Product Advisory Notice

Issue Date: April 24, 2023

Heatsink optimization

The following figure shows the differences between the original and updated heatsink.

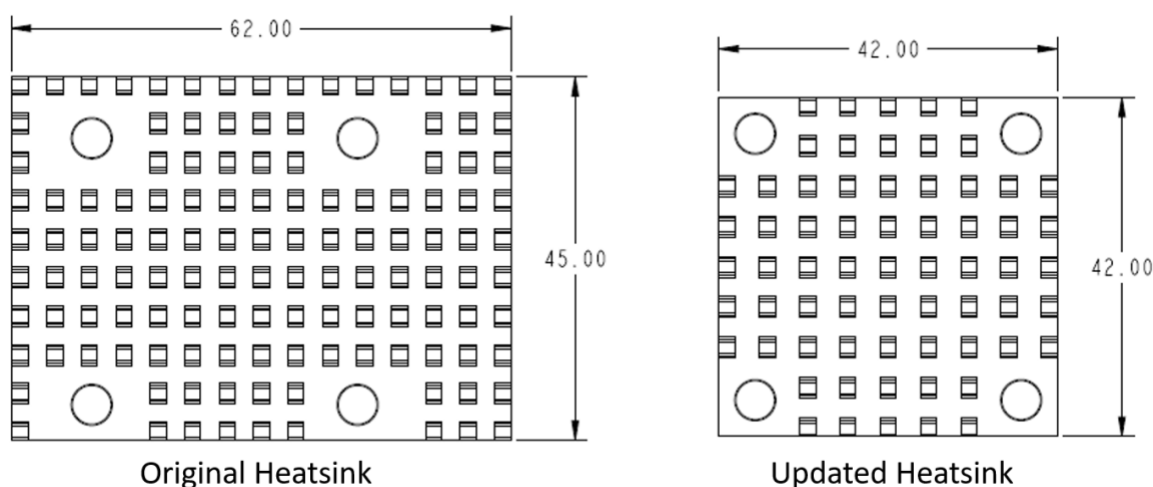
Broadcom is optimizing the heatsink on the 9560-16i/8i, 9500-16i/8i, and 9540-16i/8i adapters. These adapters all use the same heatsink. The current design has enough margin that the modification does not impact the documented airflow requirements.

Documented airflow requirements do not change. The smaller heatsink results in a minimal average increase of about 4 degrees in temperature at the same airflow rate.
